MODIFICATION NO: 20837K1857

**T I T L E : AIR-CONDITIONING - TRIM AIR PRESSURE REGULATING VALVE - INSTALL
COLOR MARKINGS**

SERVICE BULLETIN NO: A320-21-1026
PAGE: 7/8

B 
AFTER

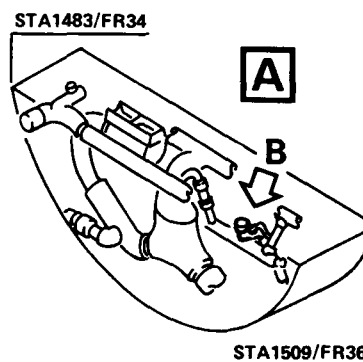
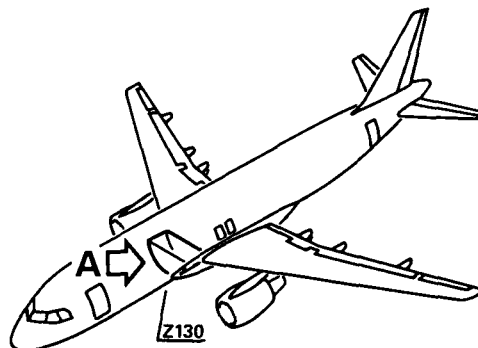
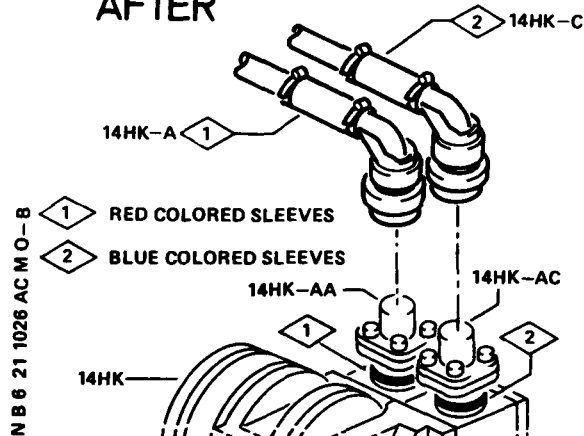
In-service experience has shown that the electrical connectors 14HK-A and 14HK-C of the Trim-Air Pressure-Regulating Valve could be mixed up by mishandling although the connectors are different in type.

This leads to damaged pins in the sockets of the Trim-Air Pressure-Regulating Valve (TAPRV) which results in malfunction of the system. To clearly identify the connections and to avoid an unscheduled replacement of the valve, it is recommended to mark the connectors and the sockets with colored sleeves.

Identification of the Connectors and
the Sockets of the TAPRV
Figure 1

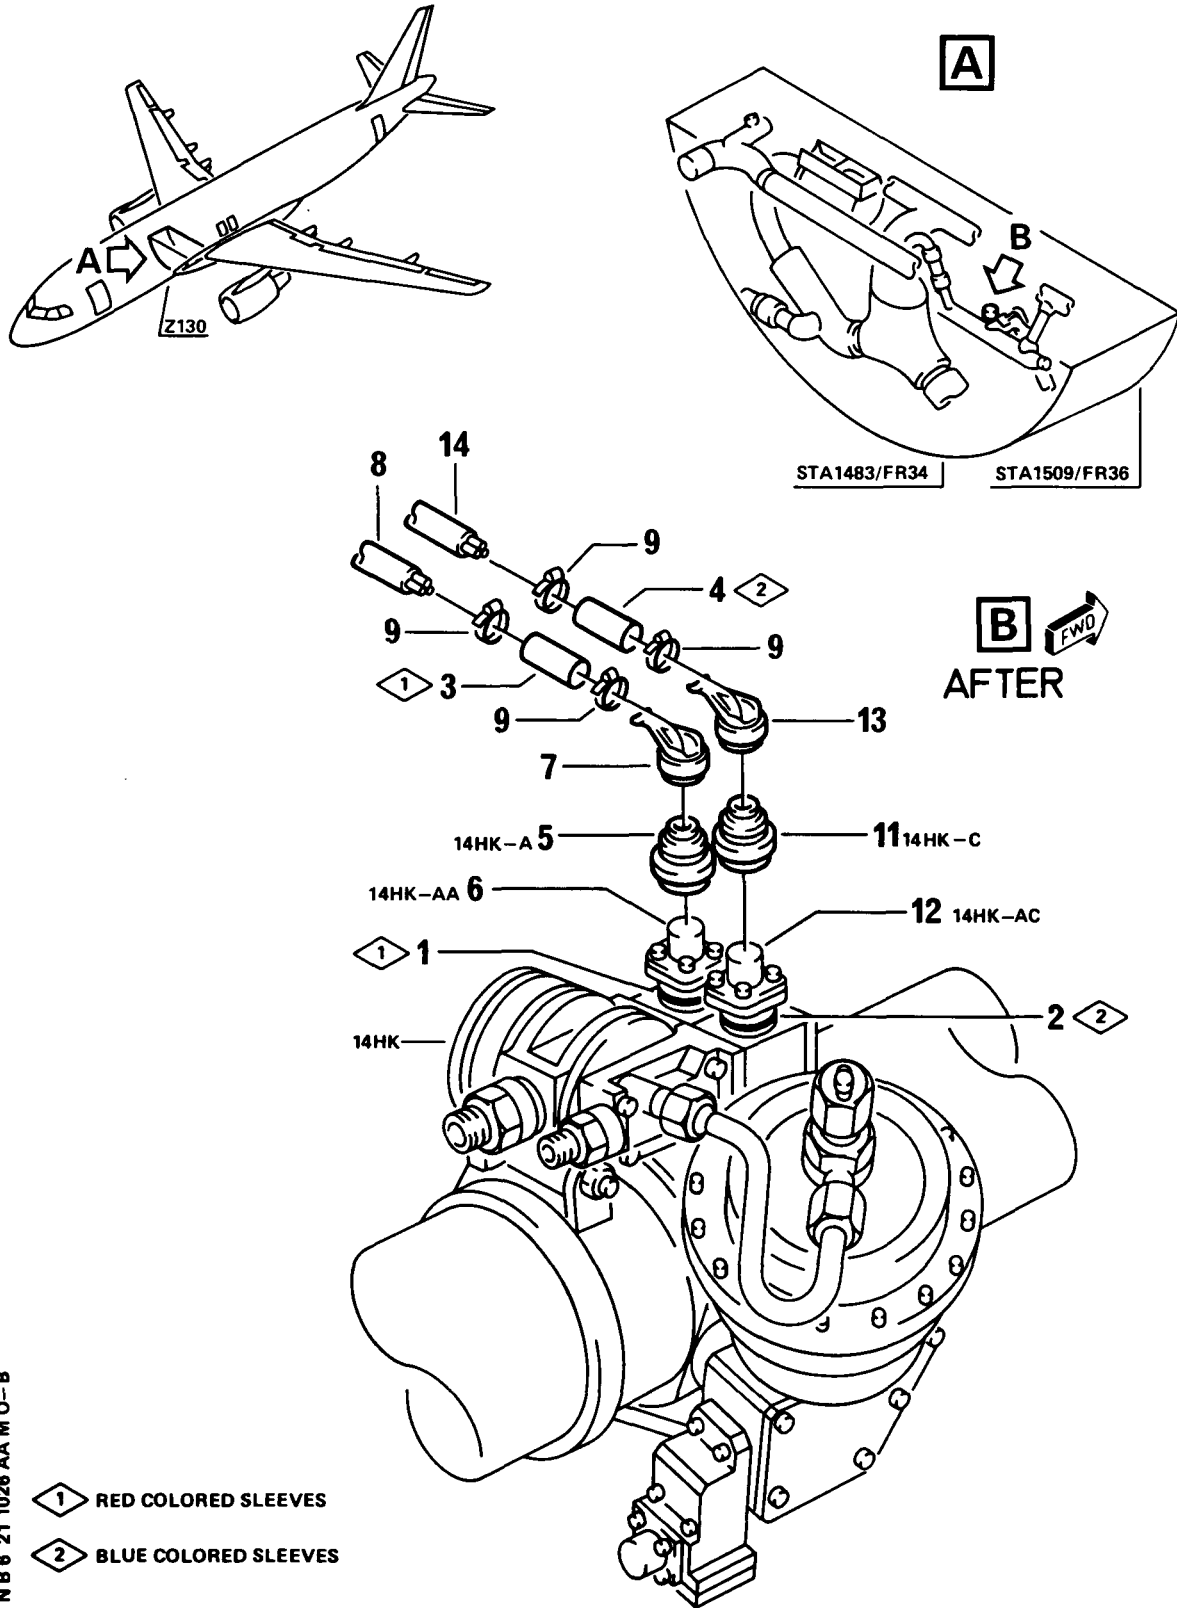
- (1) Identify, with red sleeves, the connector, 14HK-A, and the socket, 14HK-AA, of the TAPRV, 14HK, their location is between FR34 and FR36.
 - (a) Disconnect from the socket, 14HK-AA, item 6:
1 connector, 14HK-A, item 5.

- (b) Cut the red thermofit sleeve, NSA937211-008D, item 1, to a length of 8 mm \pm 1 mm (0.31 in. \pm 0.04 in.).
- (c) Attach to the socket, 14HK-AA, item 6:

- 1 red thermofit sleeve, item 1.
- (d) Heat shrink the red thermofit sleeve, item 1.
- (e) Remove and retain from the cable bundle, item 8:
 - 1 connector 14HK-A, item 5,

- 1 backshell, item 7.
- (f) Attach to the cable bundle, item 8:
 - 1 red sleeve, NSA937201MA1001, item 3, with
 - 2 cable ties, NSA935401-03, item 9.
- (g) Install on the cable bundle, item 8:

- the retained backshell, item 7,
 - the retained connector, 14HK-A, item 5
 - as shown on lines 1, 2 and 3 of Figure 2.
- (h) Connect to the socket, 14HK-AA, item 6:

- 1 connector, 14HK-A, item 5.
- (2) Identify, with blue sleeves, the connector, 14HK-C and the socket, 14HK-AC, of the TAPRV, 14HK.
 - (a) Disconnect from the socket, 14HK-AC, item 12:

- 1 connector, 14HK-C, item 11.
 - (b) Cut the blue thermofit sleeve, NSA 937211-008H, item 2, to a length of 8 mm \pm 1 mm (0.31 in. \pm 0.04 in.).
 - (c) Attach to the socket, 14HK-AC, item 12:

- 1 blue thermofit sleeve, item 2.
 - (d) Heat shrink the blue thermofit sleeve, item 2.

Identification of the Sockets of the TAPRV
Figure 3

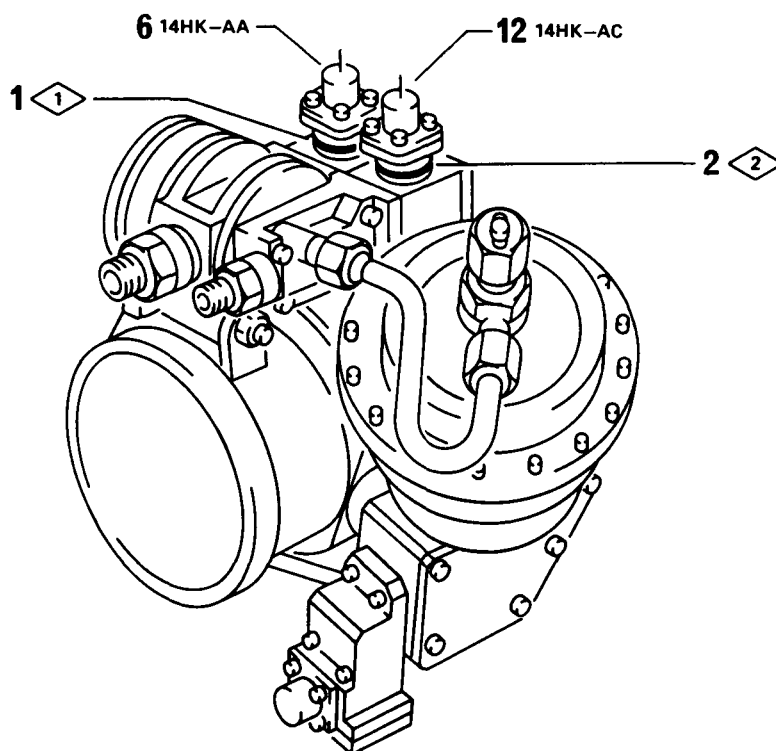
(a) Identify, with a red thermofit sleeve, the socket, 14HK-AA, of the TAPRV.

1 Cut the red thermofit sleeve, NSA937211-008D, item 1, to a length of 8 mm \pm 1 mm (0.31 in. \pm 0.04 in.).2 Attach to the socket, 14HK-AA, item 6:

(b) Identify, with a blue thermofit sleeve, the socket, 14HK-AC, of the TAPRV.

1 Cut the blue thermofit sleeve, NSA937211-008H, item 2, to a length of 8 mm \pm 1 mm (0.31 in. \pm 0.04 in.).2 Attach to the socket, 14HK-AC, item 12:

- 1 RED COLORED SLEEVE , LENGTH 8 ± 1 mm (0.31 ± 0.04 in.)
- 2 BLUE COLORED SLEEVE , LENGTH 8 ± 1 mm (0.31 ± 0.04 in.)
